2nd Preliminary Consultation
MONTGOMERY COUNTY HISTORIC PRESERVATION COMMISSION
STAFF REPORT

Address:	7155 Wisconsin Avenue, Bethesda	Meeting Date:	7/24/2019
Resource:	Individually Listed Master Plan Site Farm Women’s Market (#35/14-1)	Report Date:	7/16/2019
Applicant:	Charles T. Hathway, Agent	Public Notice:	7/10/2019
Review:	2 nd Preliminary Consultation	Staff:	John Liebertz
Proposal:	Site and building alterations, comprehensive rehabilitation, and new construction

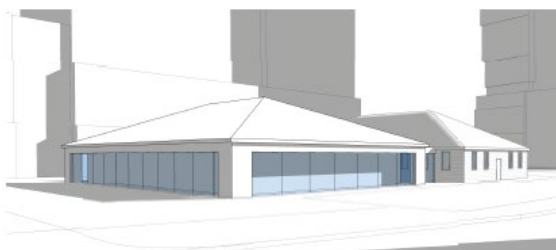
Staff supports the proposed underground parking and the relocation of the building 13' to the north. The parking garage, located within less than 10 percent of the environmental setting, would not destroy materials, features, or spatial relationships that characterize the property.

The relocation of the Farm Women's Market within the environmental setting would have minimal adverse effects to its integrity of location or setting and will not diminish character defining features of the building or landscape. The building would retain an orientation, setting, and general environment directly comparable to the historic location. The building would still express the property's association as a market, and it remains in the same architectural landscape (dense urban area). In addition, the comprehensive rehabilitation of the Farm Women's Market would require the building to be temporarily moved to install a new foundation and conduct other structural repairs (per the existing conditions and recommendations as outlined in the draft HSR). In addition, shifting the building 13' to the north would increase overall architectural compatibility by providing greater relief from the proposed adjacent high-rise building (as zoned for in the *Bethesda Downtown Plan*) and providing an appropriate setting within the new development.

- 1) Appropriateness and potential adverse effects from moving the historic building to a different location on the site;
- 2) Appropriateness and potential adverse effects from building below-grade structured under a minimal part of the rear portion of the environmental setting; and
- 3) Requirement of at least a Phase I Archaeological Survey within the environmental setting to ensure protection of any potential artifacts.

VIEW FROM THE NE ALONG WILLOW LANE
Option 1: Hipped Pavilion.

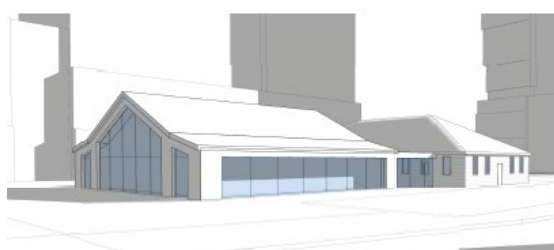
The four options depict various massing, roof forms, and general fenestration patterns that would establish the baseline for the design. The options suggest one of the four different strategies outlined above. For example, Option 1: Hipped Pavilion (page 27) correlates to the hipped-roof of the Farm Women’s Market and offers a conservative form and design approach (“invention within a style”). Option 2: Shed (page 28) and Option 3: Double Shed (page 29) both utilize historical precedents for farm markets, but differentiate from the subject building’s hipped-roof and fenestration (“abstract reference”). On the other hand, Option 4: Pavilion (page 30) distinguishes itself from the architecture of the historic building type and setting (“abstract reference” and/or “intentional opposition”).

VIEW FROM THE NE ALONG WILLOW LANE
Option 2: Shed.

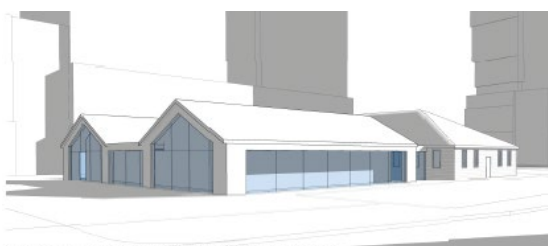
Staff finds the preliminary height for the conceptual addition to be compatible with the Farm Women's Market, unlike the previously proposed detached, two-story, retail pavilion building. The previous concept presented in January maximized the height allowable by zoning (35') and negatively impacted the historic setting and views from Wisconsin Avenue as it exceeded the ridgeline of the market by 10'. All of the proposed additions for consideration in this preliminary consultation would be equal to or less than the ridgeline of the market (25'). Therefore, the market would remain the central focal point within the setting as views of the addition would be obscured when looking east from Wisconsin Avenue.

Staff concurs with the applicant's assessment that a direct addition as shown in Sketch 1 (page 25) would diminish the building's integrity of design due to the incompatible proposed footprint and scale. The remaining four detailed options (pages 25 and 27-30) separate the addition from the original market by means of a recessed hyphen. The hyphen: 1) minimizes adverse effects to the east (rear) elevation and overall form of the historic building; and 2) retains a greater degree of the market's architectural significance as the only remaining women's cooperative market in the state. Staff concurs with the applicant's approach to explore further only additions attached by means of a hyphen.

VIEW FROM THE NE ALONG WILLOW LANE
Option 3: Double Shed

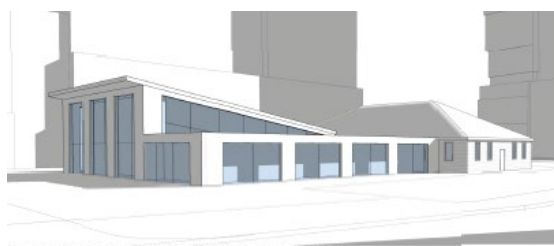
- 1) Appropriateness of the applicant’s overall conceptual approach.
- 2) Appropriateness of the approximate size/footprint, location, massing, and fenestration pattern of the four proposed options.
